Differences between model HX40V and HY40V

Vehicle Manufacturer: IVECO

Engine code: CURSOR 8 / 10

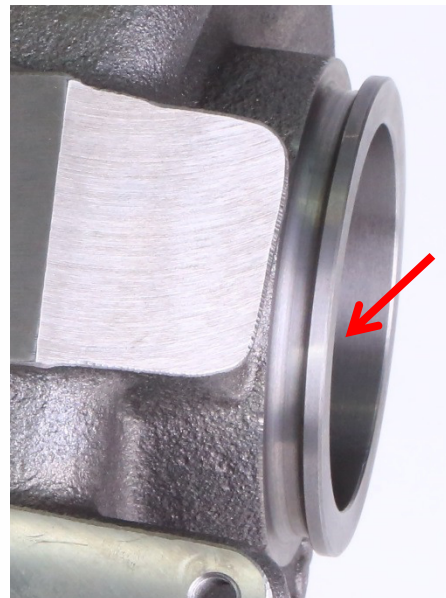
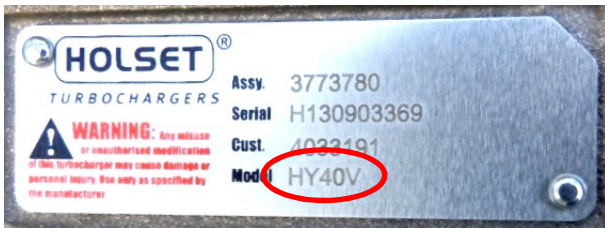
The obsolete HX series has a flat screwed flange on the turbine output.

In the latest HY-series exhaust system with V-band clamp is mounted on a conical seating.

The refitting of turbocharger model series **HX** on model series HY, or HE may be carried out only by a IVECO specialist workshop. The engine control unit must be reprogrammed and it has to be installed modified components of the exhaust and intake system to build in.

Insofar in your vehicle a turbocharger model series HY40V has already been installed, the delivered turbocharger can be replaced directly. A programming of the controller is not required.
